From:
Monks Orchard Residents' Association
Planning

Reference:	19/01352/FUL
Application Received:	Wed 20 Mar 2019
Application Validated:	Wed 20 Mar 2019
Address:	56 Woodmere Avenue Croydon CR0 7PD
Proposal:	Demolition of a single-family dwelling and erection of a 3- storey block containing 2 x 3-bedroom and 7 x 2-bedroom apartments with associated access, 9 parking spaces, cycle storage and refuse store (amended plans and description)
Consultation Close:	Thu 13 June 2019
Neighbour Consultation Date	Thu 20 Jun 2019
Target Date:	TBA
Case Officer:	George Clarke

Resultant on the provision and notification of amended drawings, we have revised and updated our objection letter to take account of these changes to this development proposal. It is noted that the footprint of the proposal remains exactly the same and only the internal configuration has been modified to improve compliance to **London Plan Policy 3.5 – Minimum Space Standards**. The main issue of **excessive and inappropriate Residential and Housing Densities** has been exacerbated and remains a significant **non-compliance** and reason for objection and **refusal** of this proposal.

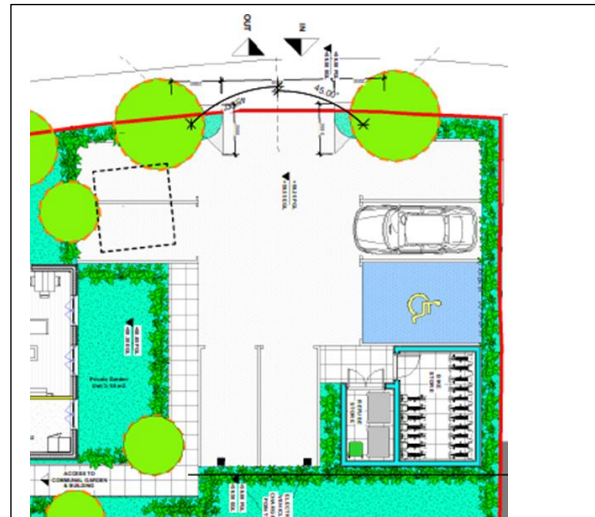
The parking provision is for two spaces fronting Woodmere Avenue and seven spaces, including one disabled parking bay on the forecourt fronting Round Grove of the proposed development which is **contrary to Policy DM10.2**, although screened by shrubs. It is not stated the variety of shrub or height of matured specimens to afford adequate screening to meet the policy requirement.

There are no swept path diagrams showing ingress and egress for the Round Grove parking bays and it is considered that if all bays are full, after entering bays 08 and 09 in a forward gear, it would not be possible to change direction within the forecourt to exit the forecourt from bays 08 & 09 safely in a forward gear.

There is insufficient turning space to undertake a three-point turn to exit the forecourt in a forward gear. It is extremely unwise to allow parking designs which prevent exiting over the footway and into the road in a forward gear inhibiting visibility and thus the safety of passing pedestrians.

Rear aspect of 54 Woodmere Avenue

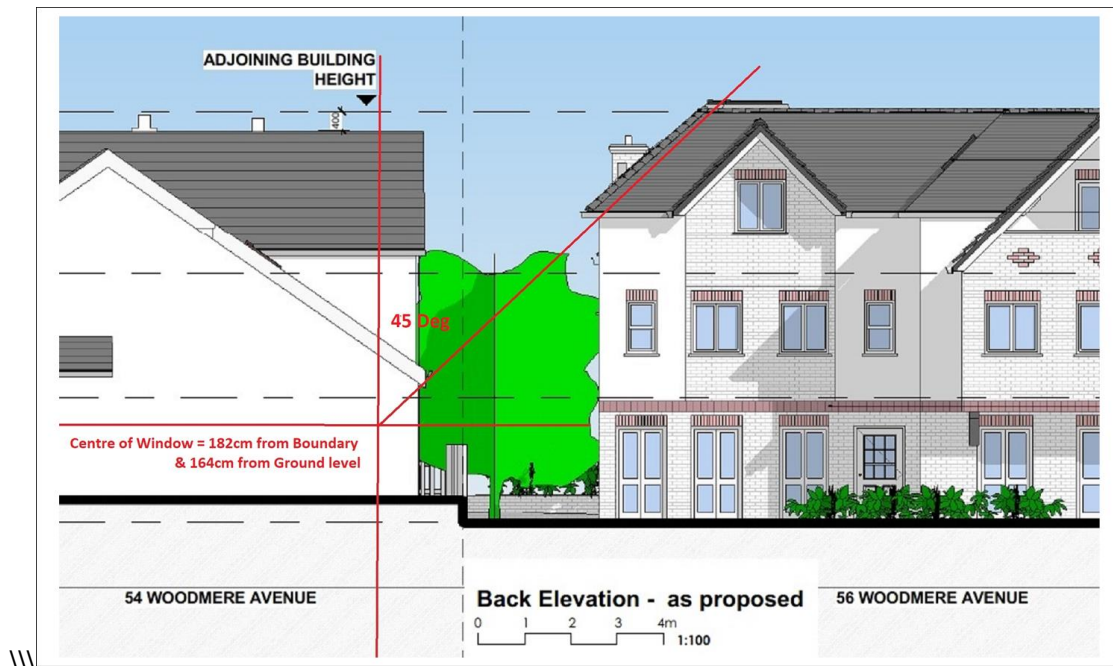
The owner of **54 Woodmere Avenue** has provided the measurements for the Centre of the ground floor window at **182cm** from the boundary and **164cm** from ground level.

This illustrates that the proposed development **fails to meet the 45° rule on height (see below) and will intercept the 45° projection** in relation to the **adjacent property**. It should be recognised that the proposed development is to be **sunk into a 0.6m hole in the ground** in order to meet the adjacent properties height restriction.

ground, the built form would be **0.6m higher** and the projected **45° Rule** would show much more of the proposed development would be **above the 45° intercept projection** and significantly greater non-compliance to the policy. **The built height is therefore extremely critical.**

These projections are based upon the provided plans with dimensions scaled off when magnified at 112% which gives 1cm = 1m. This illustrates an overbearing nature of the proposed development on the adjacent property at **54 Woodmere Avenue**.

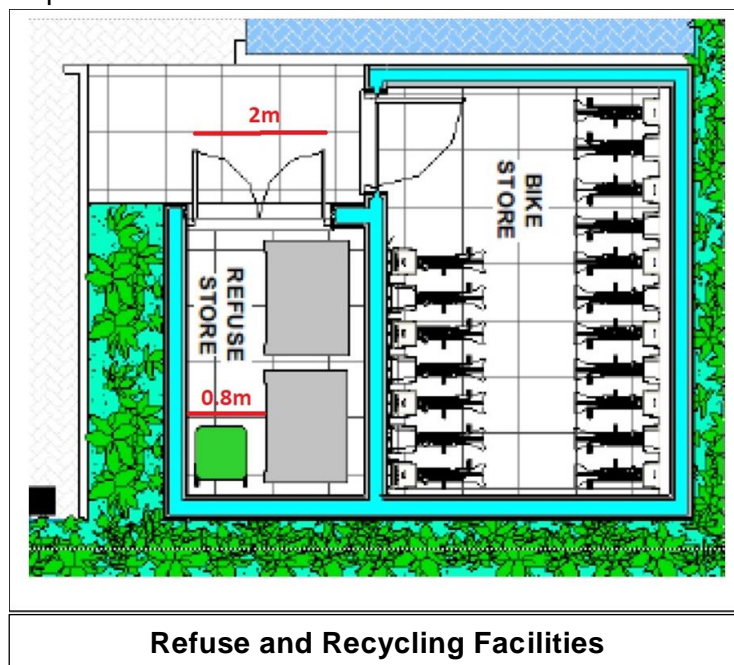
It is understood that there must be a minimum of **150mm clearance** around and between each bin within a storage area. Where there is more than **one bin within a storage area**, as is the case for this proposed development, there must be **2m clearance in front of each bin** to enable it to be accessed and safely moved without needing to move any of the other containers. The proposed development **does not**

provide this 2m clearance in front of the bins to allow safe movement.

It is also understood that the access doors to the bin storage must **not open outward** over a **public footway or road**, and should **not** cause any **obstruction** to other accesses when in an open position. The proposed development Refuse Storage doors **DO** open outwards and **DO** obstruct access to the adjacent Bike store.

It is understood that a water supply, with standard tap fittings be available to the bin storage area to enable washing down of the bins, walls and floor. This requirement is not shown on the plans.
